March 16, 2012

Re: **Response to IDEM's Request for Revised Remediation Work Plan
Approval Review and Technical Response to
General Notice of Potential Liability Review
Michigan Plaza**
3801-3823 West Michigan Street
Indianapolis, Indiana 46222
IDEM VRP #6061202
MUNDELL Project No. M01046

FIGURE
8

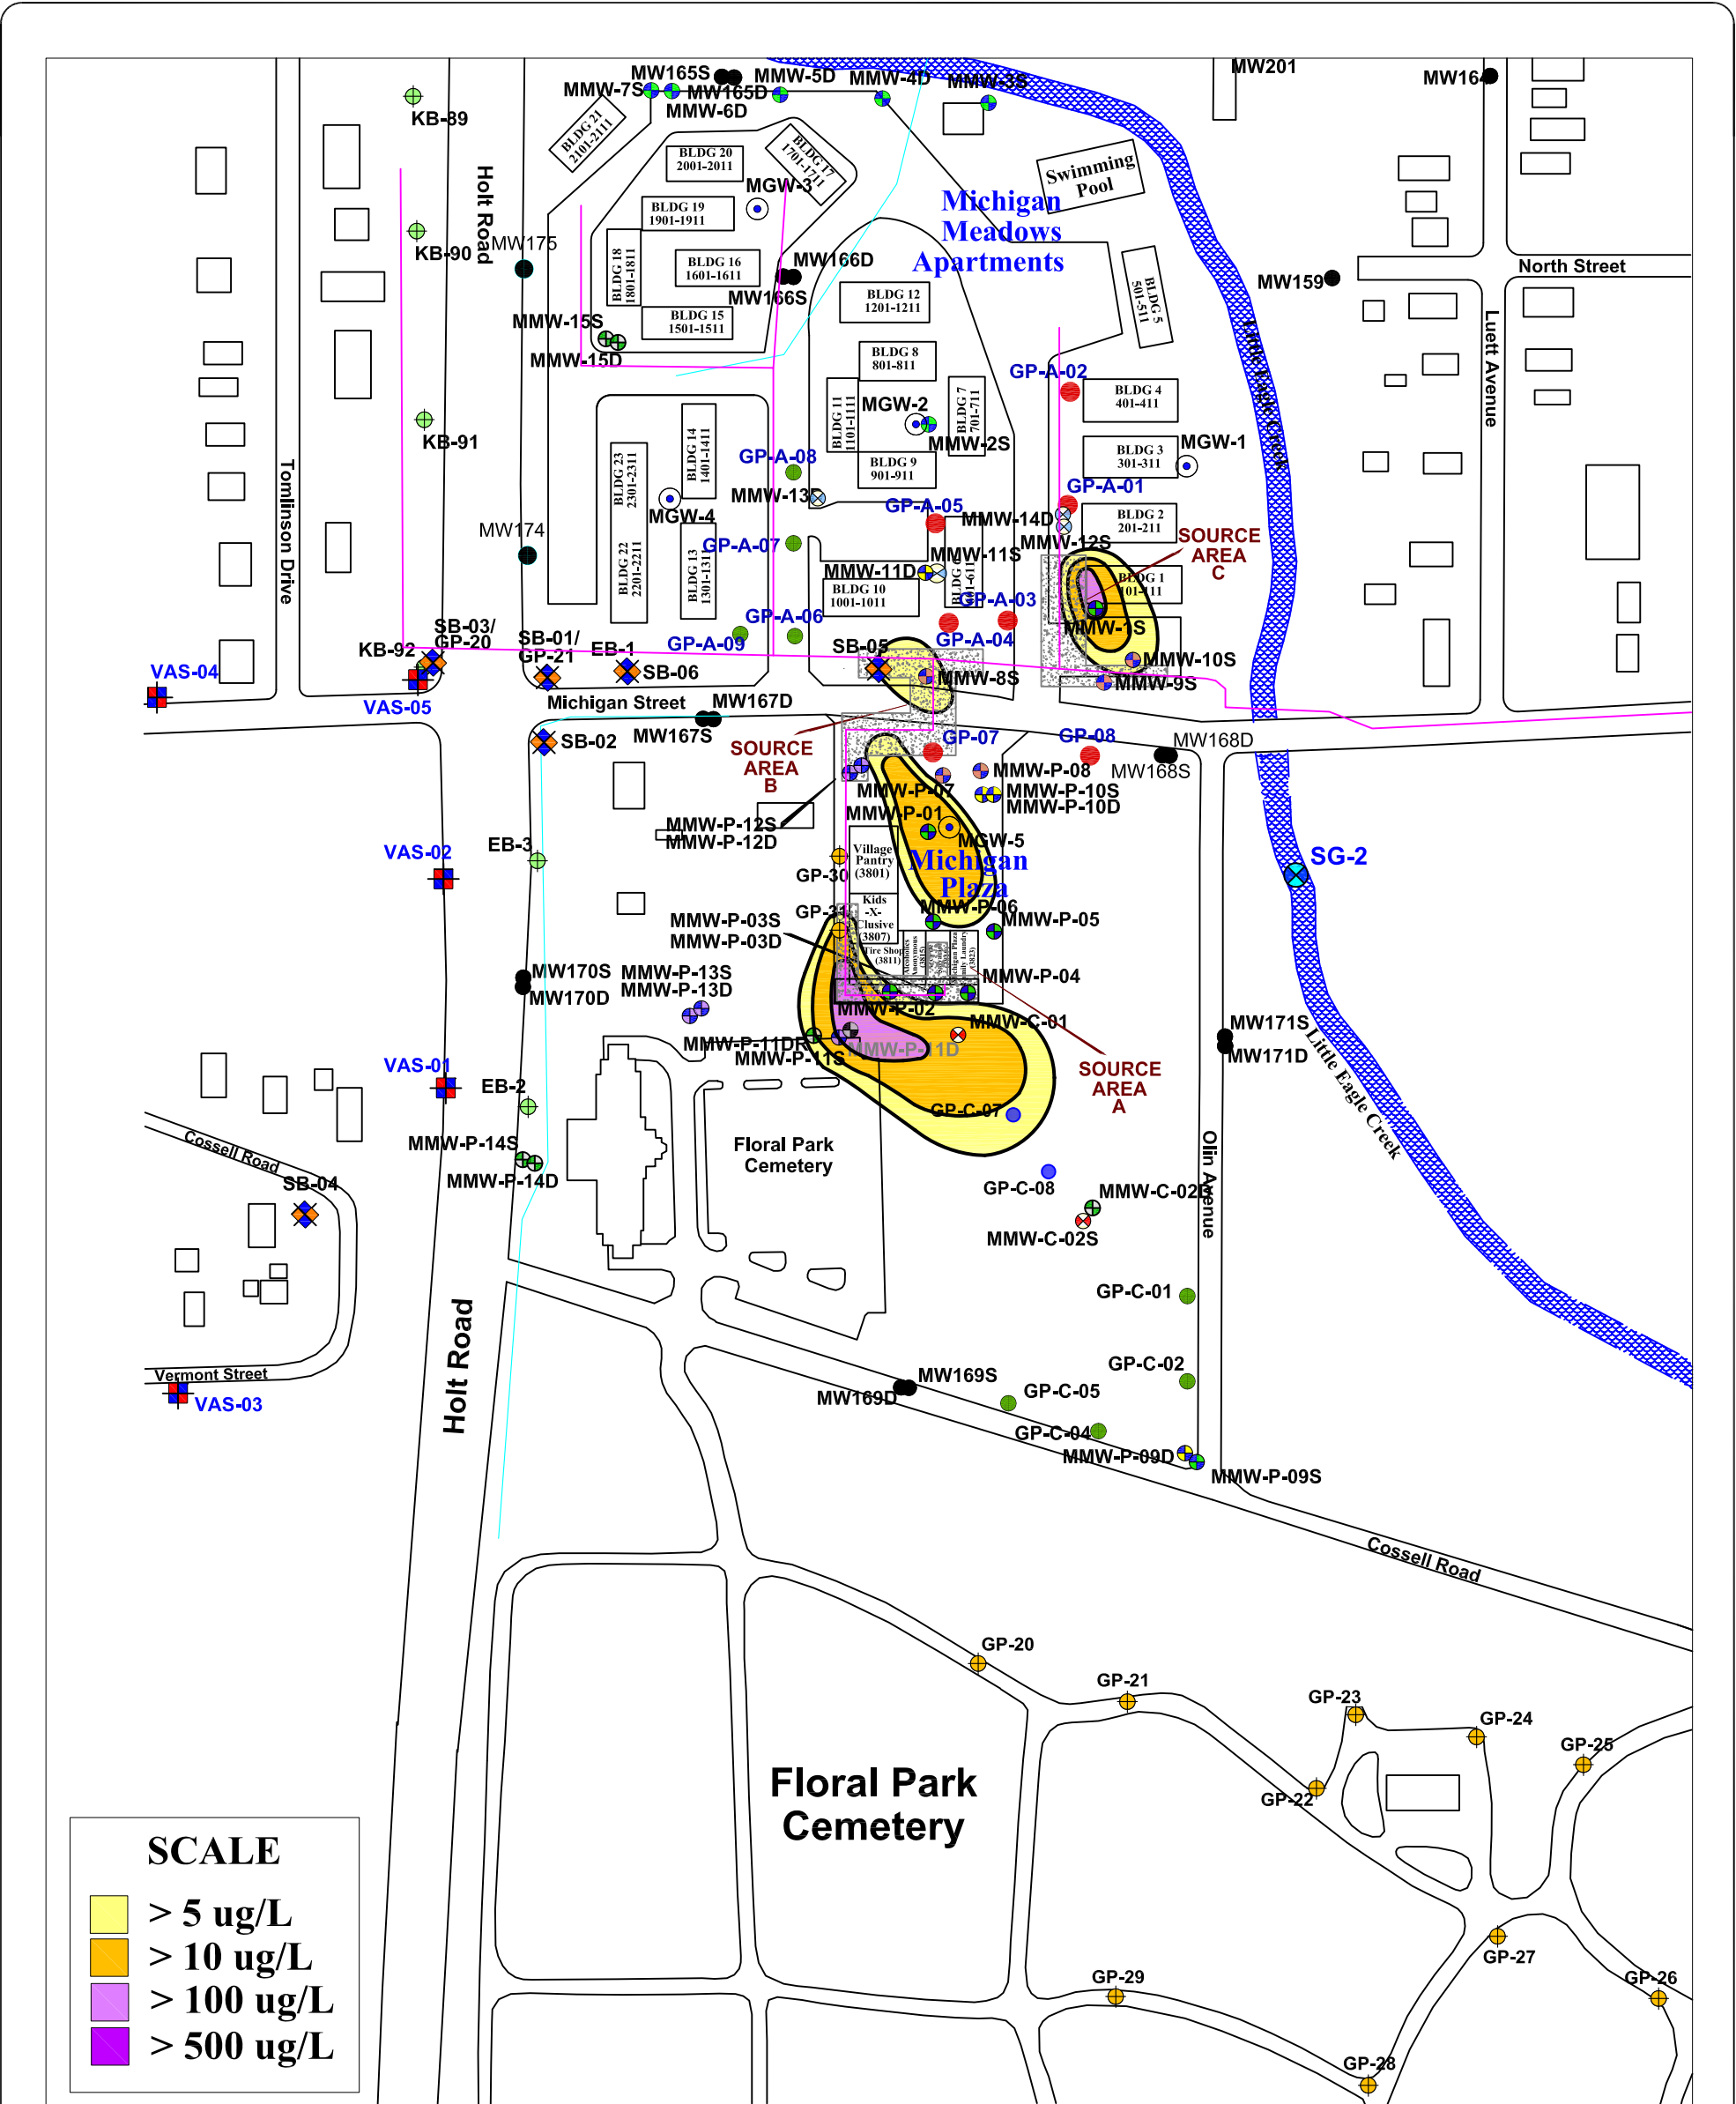
IDEM Comment No.6. *"In addition to complete delineation to the west of the Plaza, the plume is also not delineated south of MMW-P-09D, which contains vinyl chloride above RISC Industrial Default Closure levels. As requested in IDEM's November 17, 2008, comment letter additional delineation is necessary to determine the extent of VC."*

MUNDELL has completed downgradient delineation of the deep VC impacts in 2011 with a series of geoprobe borings as previously described (see **Figure 18** and *Additional Investigation Activities Summary Report*). Based on the results of this investigation, the VC extent in the deeper portion of the aquifer has been delineated. As noted above, MUNDELL proposes to augment the existing monitoring well network with the addition of two additional monitoring wells (south of the southwest corner of **Source Area A** and in the Floral Park Cemetery south of Cossell Road).

FIGURE
9

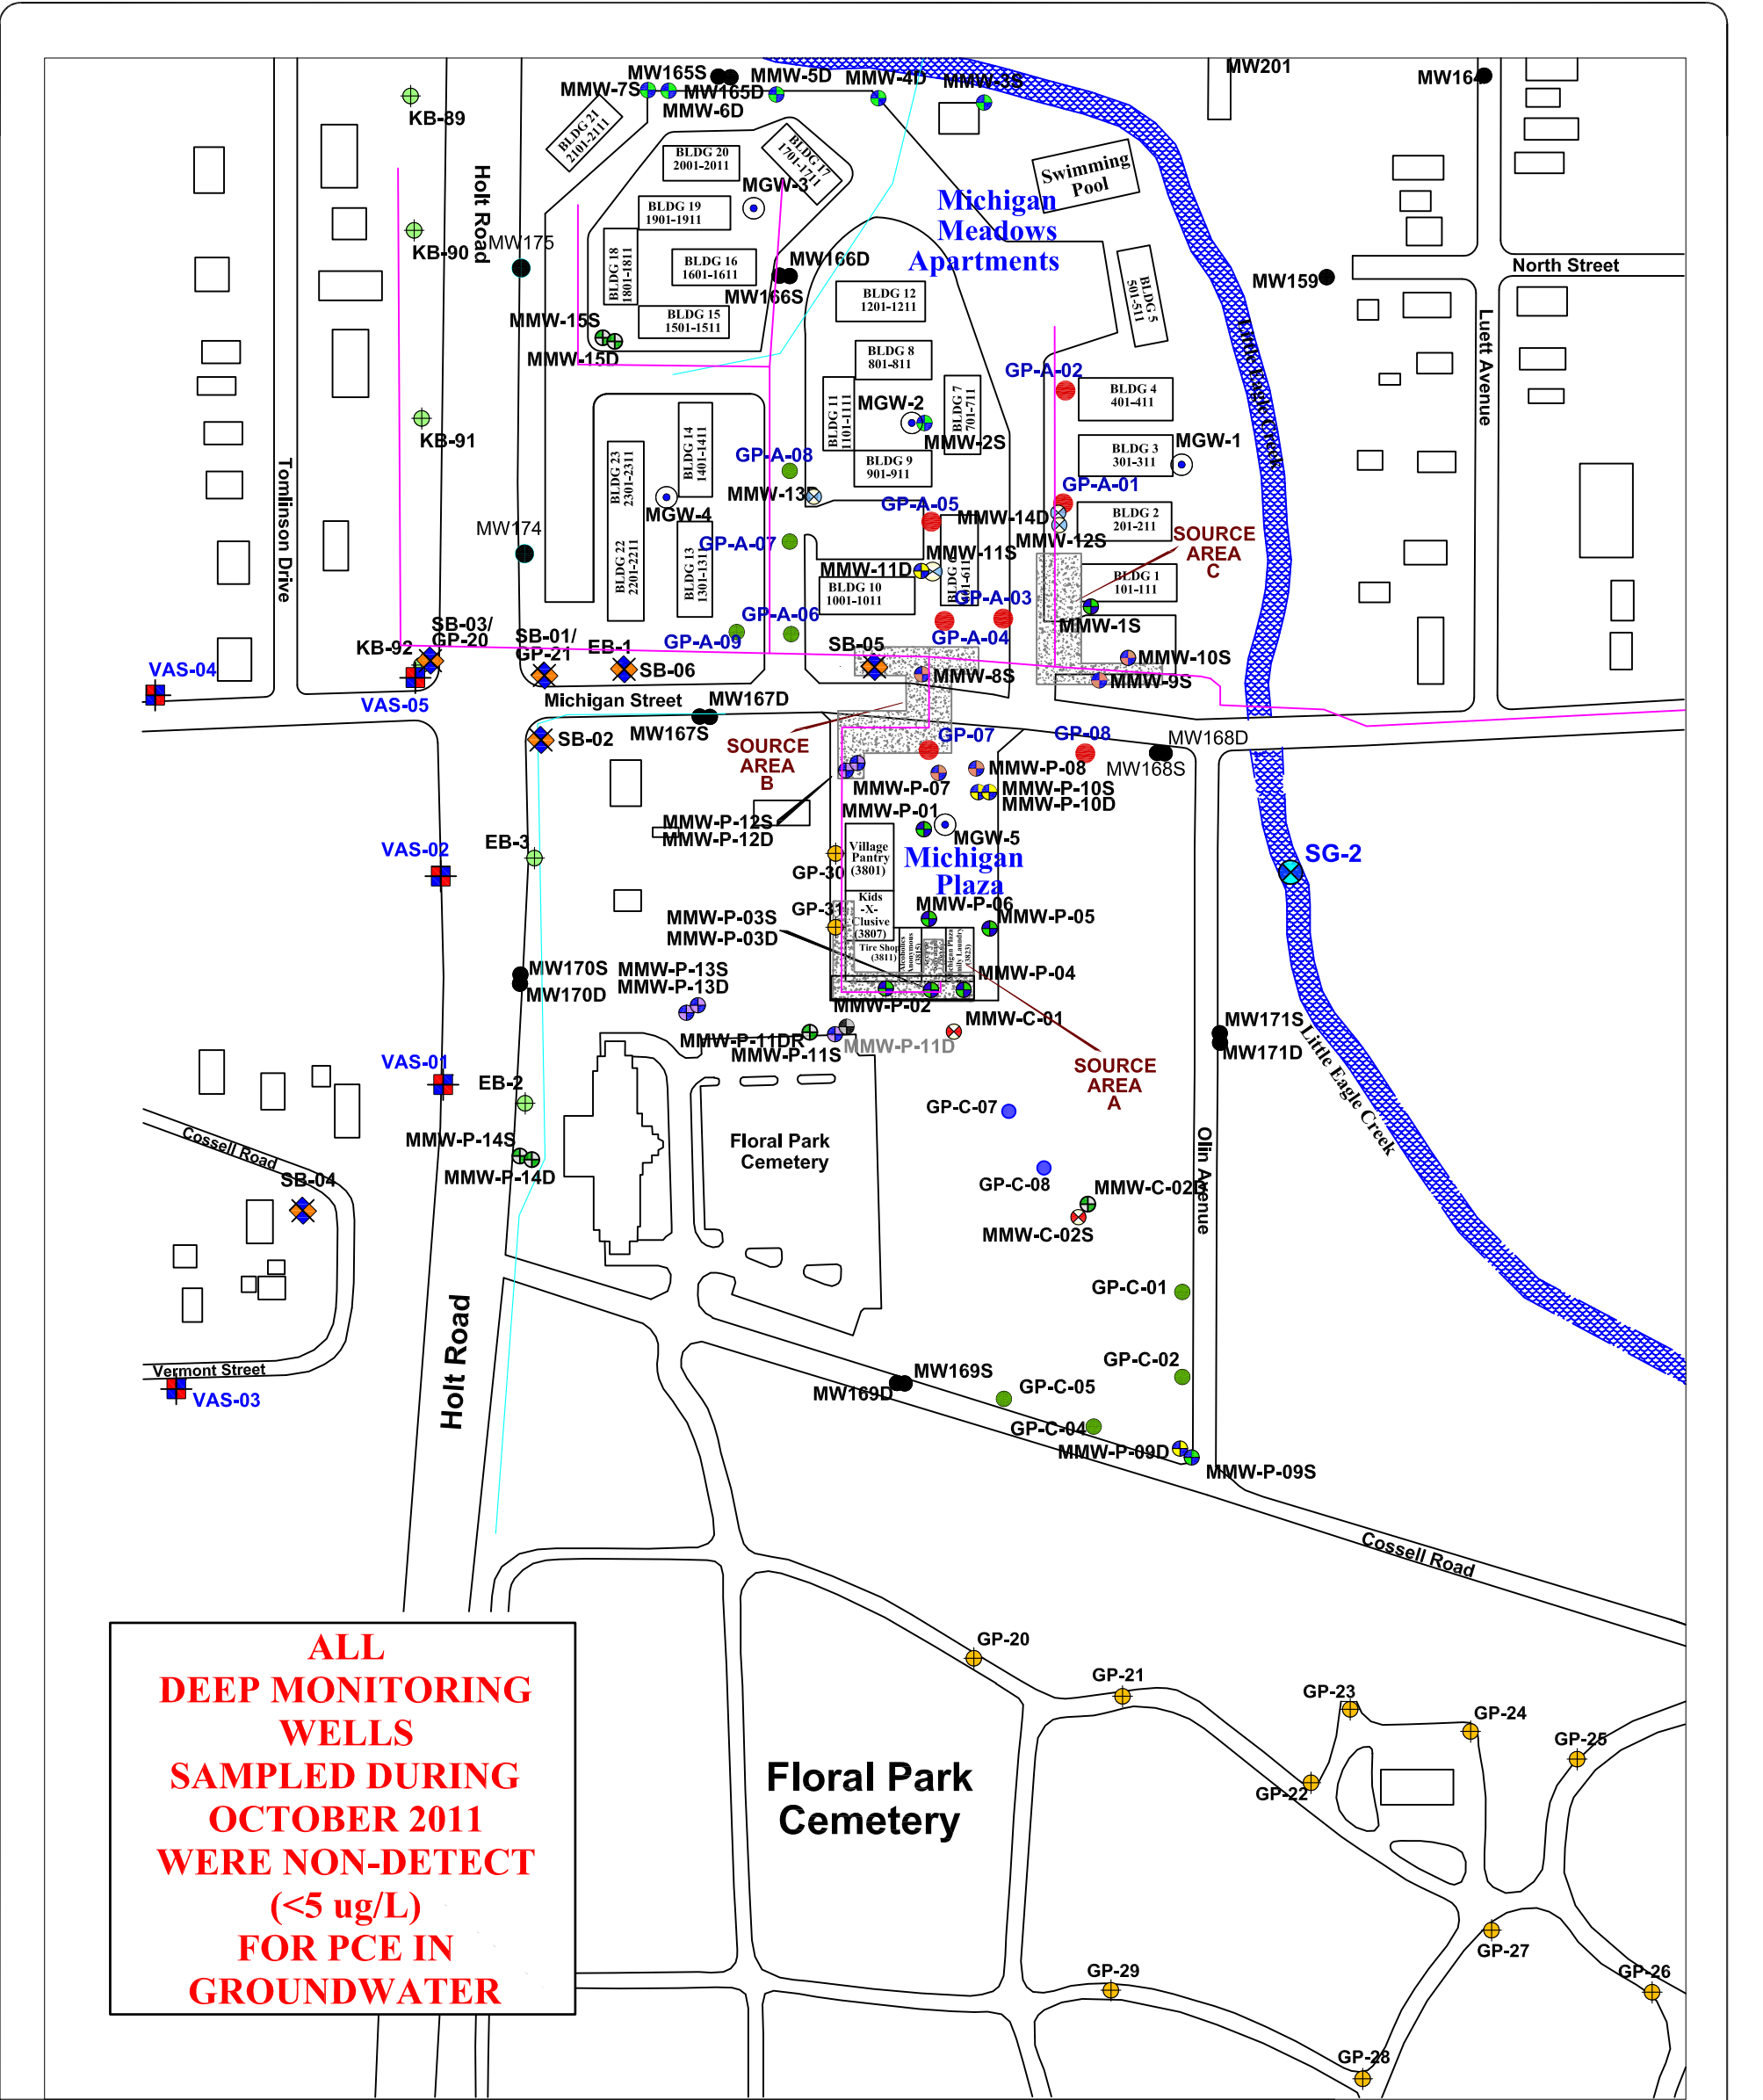
IDEM Comment No.1. *"Reviewing this report prompted IDEM to perform a confirmatory review of the soil and groundwater sampling completed prior to the CAP 18 injections in August 2007. From this review, IDEM cannot concur that the Michigan Plaza source areas and groundwater plume are fully defined. IDEM also cannot agree that the deep contamination across the site is wholly the responsibility of Genuine Parts or that Michigan Plaza cannot be the source of the vinyl chloride contamination in the residential drinking water wells. Additionally, a review of the 2005 sewer line investigation shows that the line along the immediate west side of the Michigan Plaza building was in poor condition, with worn joints and sags in the line. Since this part of the line was in similar condition to the lines in the known source area, is closer to the dry cleaner, and has not been investigated, it is inaccurate to definitively state that the source areas are fully delineated or that the vinyl chloride in the residential drinking water well cannot be from the Michigan Plaza source areas. Additional investigation to the west of the Plaza is required."*

Updated PCE plume delineation maps for shallow and deep groundwater within the sand and gravel unit based on 4th Quarter 2011 groundwater analytical data collected by MUNDELL, are provided as **Figures 9 and 10**, respectively. In addition, the grab groundwater sample obtained by the EPA at EPA boring location SB-5 located in **Source Area B** during December 2011 indicated that a PCE concentration of 9.7 ug/L remains at that location. After two rounds of CAP18TM injections in August 2007 and February 2009 following the Remediation Work Plan recommendation to implement in-situ bioremediation of the PCE source areas and groundwater via the reductive dechlorination pathway, there are currently no detectable concentrations of PCE in the deep groundwater and limited areas of remaining shallow PCE impacts are present in each chemical source area. Additional soil and groundwater sampling along the western property boundary (soil boring GP-31) indicates a PCE source area remains in the vicinity of GP-31 south to the intersection of the north-south sewer line with the east-west leg of the sewer along the southern edge of the Michigan Plaza building. This area of **Source Area A** is an area that has not received CAP18 injections previously, and is already scheduled to receive them during the second quarter 2012. The other three areas of observed residual PCE impacts (two associated with **Source Area B** and one

associated with **Source Area C** as seen in **Figure 9**) are also planned for an additional injection, according to the MUNDELL July 22, 2011 *Revised Work Plan for Third Round of CAP18 METM Injections*.

First, two soil borings advanced along the western sewer line (GP-30 and GP-31), in an area that was previously inaccessible due to the presence of power lines, indicate that it is likely that some limited release of PCE occurred either at or just north of GP-31 but south of GP-30, and also at or near the junction where the north-south sewer joins the east-west sewer line extending from the former Accent Dry Cleaner. In addition, a PCE soil release was observed in the MMW-P-12 area. The western sewer line segment has
